747.

A map given to us by Kalbar.

From: Ian Magee
Sent: Monday, 3 May 2021 3:09 AM
To: Fingerboards Inquiry and Advisory Committee (DELWP)
Cc: Ian Magee
Subject: Failure by the Consultant SGS and the Proponent to Report the Most Significant Source of Radiation Exposure – the Risk Of Loss Of Life.

Above: The project site area and nearby land in horticultural production.

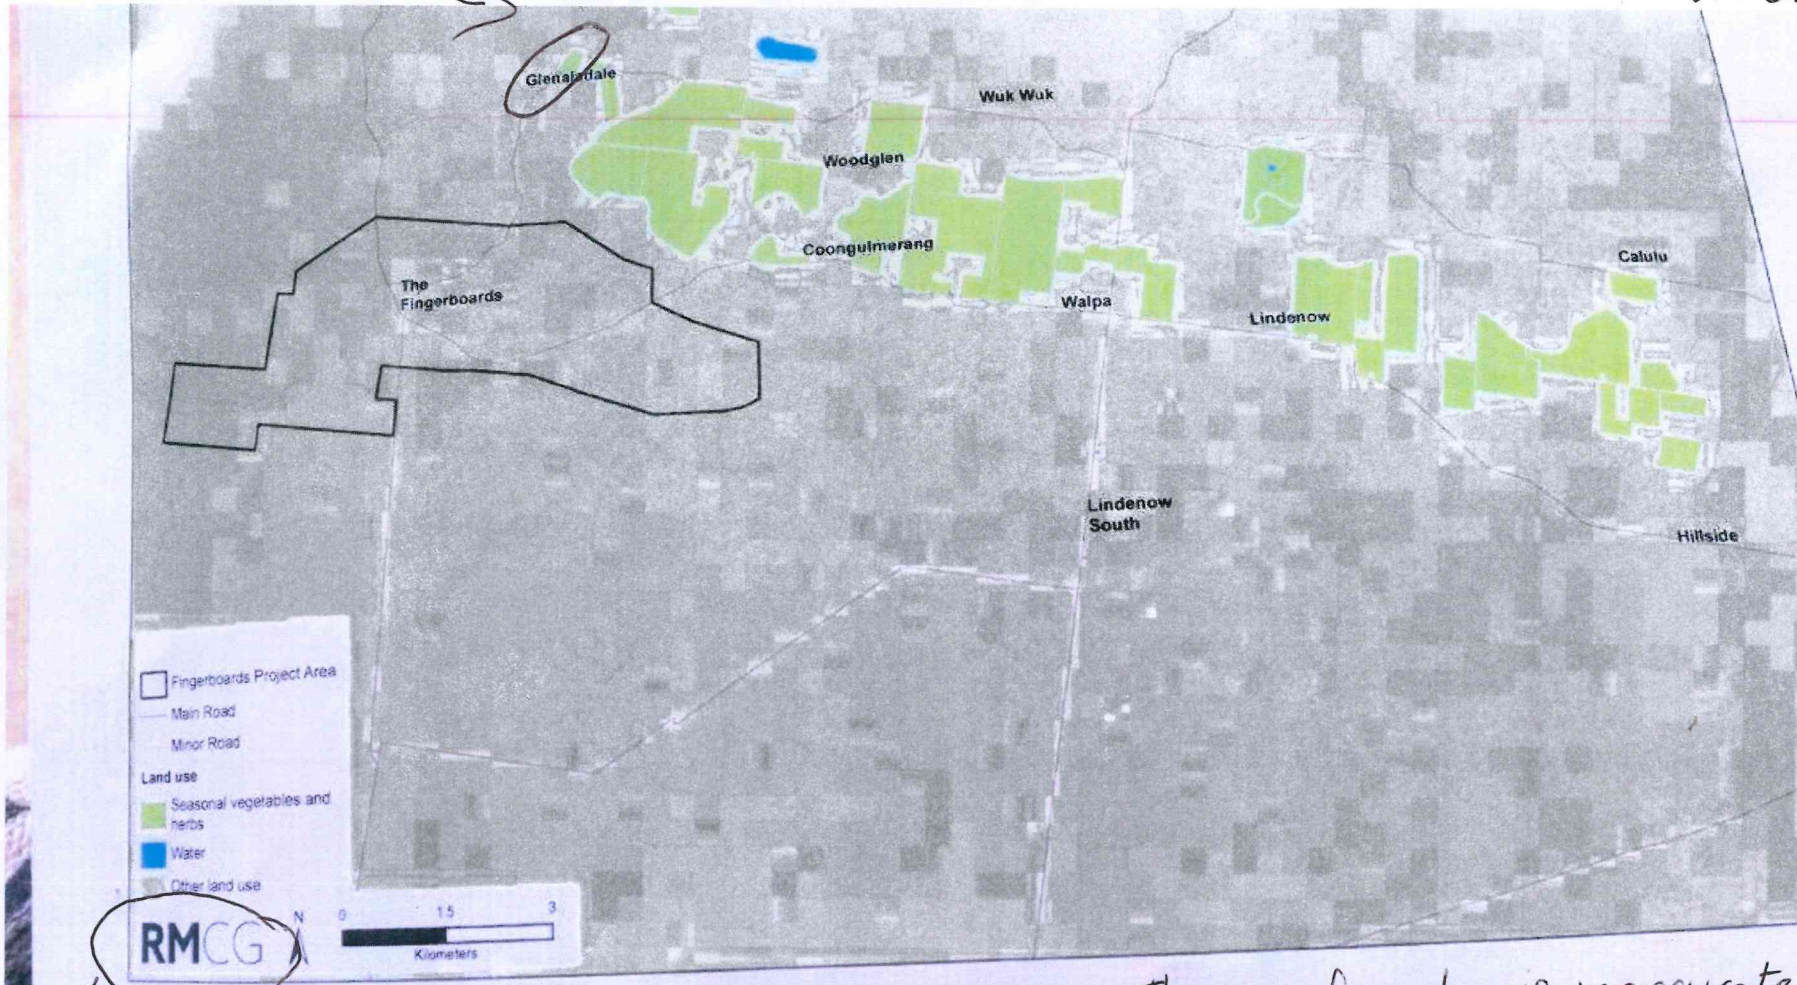
Showing mine area + nearby horticultural areas

our farm is shown as a horticultural area, which it has not been for over 10 years. Since we owned it.

This information is inaccurate + did not even actually visit the areas.

I drive around here everyday + there is definitely a lot more horticultural areas than on this map.
